DUNE FD1 PDS final design review

Replies to Q6 (noise) and Q7 (aging)

24 march 2023

For the DUNE FD1 PD consortium

A. 48 SiPMs + cold amplifier in LN2, read out with oscilloscope

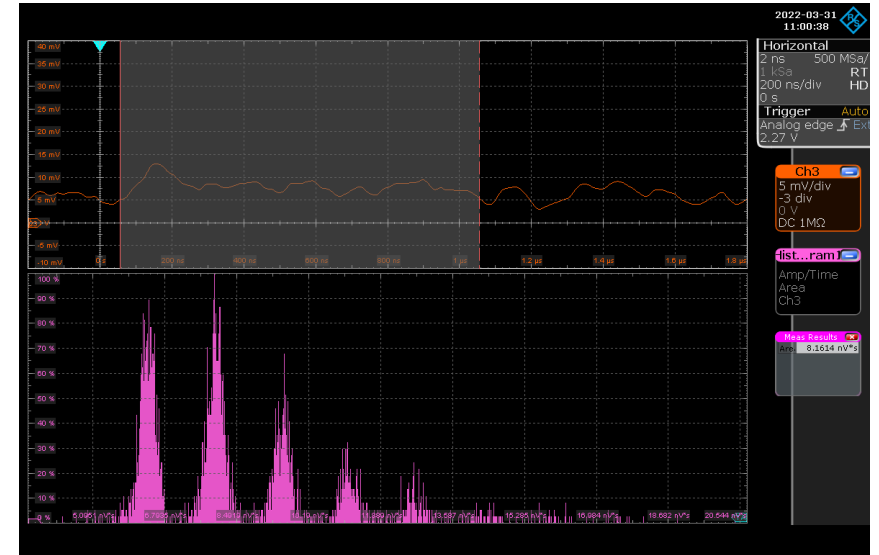
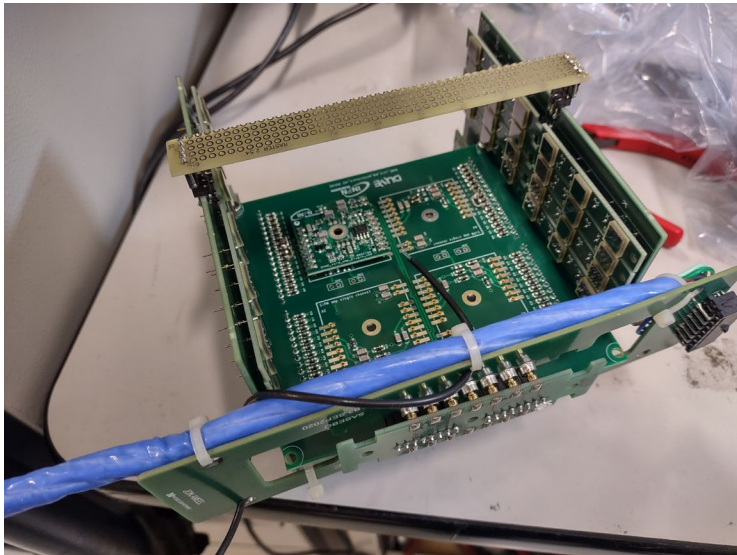
Q6. Questions on S/N with respect to noise environment

(i) How was noise characterized in the measurements of S/N in each case? How much random and how much correlated in each setup?

Results give $S/N \approx 8$ for both SiPM models at overvoltage corresponding to 45% PDE ([Slide 7](#) of F. Terranova's talk).

The S/N here is given by the series noise of the amplifier (0.37 nV/ $\sqrt{\text{Hz}}$) and thermal noise of the SiPM quenching resistor (48 SiPMs in parallel are equivalent to a source impedance of about 7 Ω , which at LN2 gives ≈ 0.2 nV/ $\sqrt{\text{Hz}}$).

The measured S/N matches what is calculated from these sources, as detailed in this paper, section 6, doi:10.1088/1748-0221/17/11/P11017.

This is intended as the upper limit that can be reached with this design of SiPMs and cold amplifier, at overvoltage corresponding to 45% PDE.

B. 48 SiPMs + cold amplifier in LN2, read out with DAPHNE

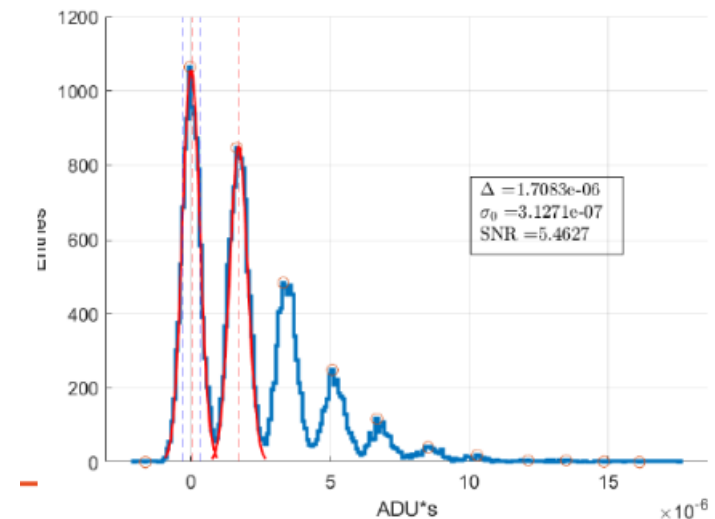
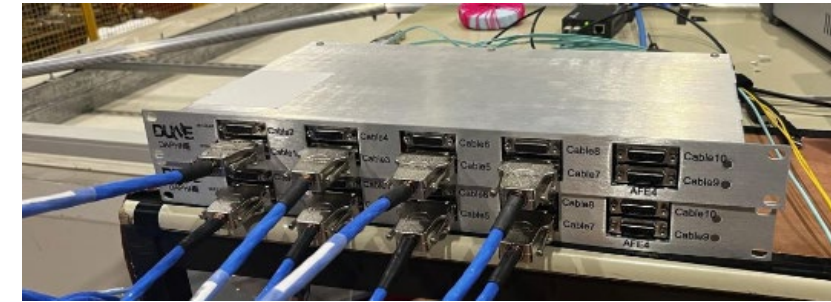
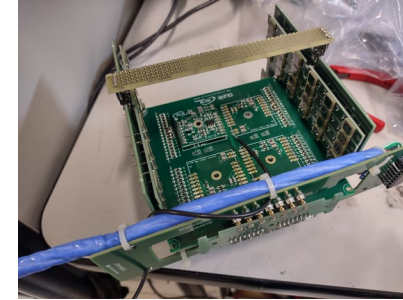
Q6. Questions on S/N with respect to noise environment

(i) How was noise characterized in the measurements of S/N in each case? How much random and how much correlated in each setup?

Results currently give $S/N \approx 5$ for both SiPM models at overvoltage corresponding to 45% PDE ([Slide 10](#) of F. Terranova's talk).

The S/N here is degraded compared to case "A". This can be due to:

- Quantization noise of the DAPHNE digitizer (amplitude of 1 p.e. corresponds to 8 ADU, so that 2000 p.e. fit in its 14 bits nominal dynamic range). A slight improvement is indeed observed if the internal gain of the AFE5808 chip is increased (this involves an obvious trade-off with dynamic range)
- $1/f$ noise in the AFE5808 front-end circuitry. This can be slightly reduced by enabling the AFE5808 baseline integrators (this involves a less-obvious trade-off with dynamic range, which reduces by a factor ≈ 2 with integrators on)
- EMI or environmental disturbances, since in these measurements the DAPHNE grounding was not yet in its final configuration.

Although the target $S/N > 4$ has already been reached, this is still under study.

C. Supercell + cold amplifier in LAr, read out with oscilloscope or digitizer

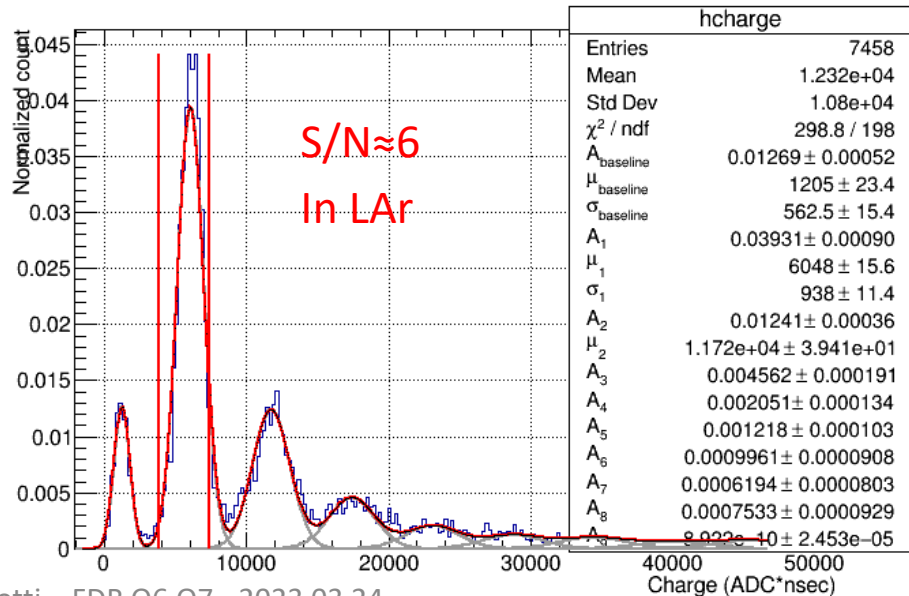
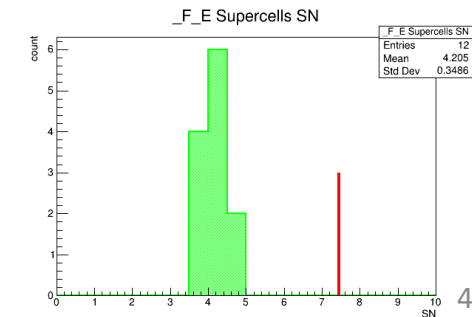
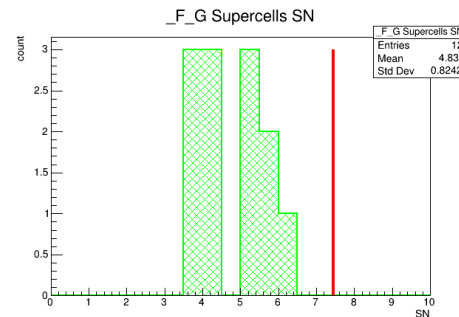
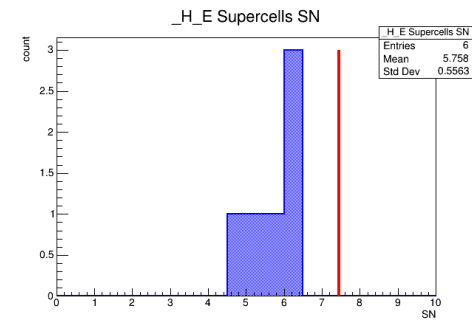
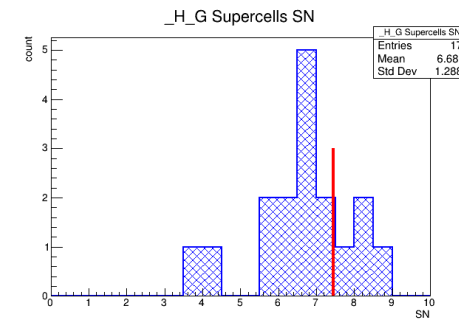
Q6. Questions on S/N with respect to noise environment

(i) How was noise characterized in the measurements of S/N in each case? How much random and how much correlated in each setup?

This was tested in different labs. Results give $S/N \approx 4-6$ depending on conditions.

The S/N here is degraded compared to case "A". This can be due to:

- Higher signal rate in LAr (39Ar, cosmics, ...)
- EMI or environmental disturbances

Still under study. Measurements with Supercell in LAr + DAPHNE are planned.

(They have been done, but the pulsed LED was not available at that time, so the S/N cannot be easily estimated from that dataset.)

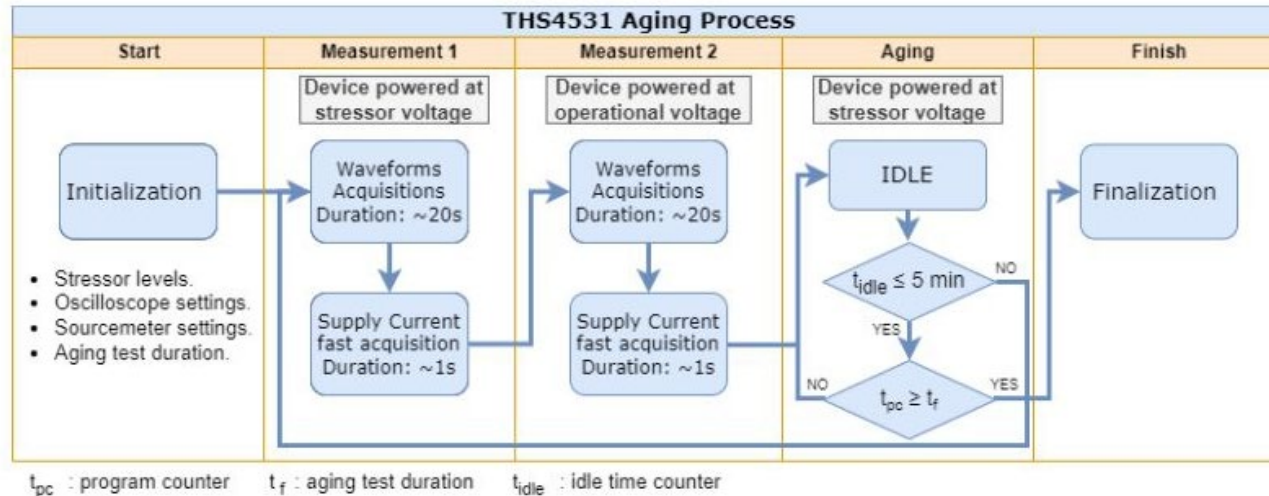
Q7. Aging tests on cold electronics

(i) Provide detailed procedure for aging tests, including op amp in addition to transistor and how power supplies were operated during the tests.

The measurement and results are described in the QA/QC document EDMS 2847126, chapter 2. The opamp is covered in section 2.1.4.

The document is being updated since the review, to include more details on the procedure.

It now includes the diagram below, illustrating the procedure, and a paragraph discussing (absence of) self-heating effects.

Aging is estimated based on a 1% variation of the current measured at the stressor voltage.

No degradation is observed when the power supply is lowered to the operational voltage.

The current measured at the operational voltage is constant, except for periodic variations on a timescale of hours, which are due to fluctuations in the temperature of the room. The current measurement at operational voltage is used to cancel these fluctuations from the current measured at the stressor voltage.
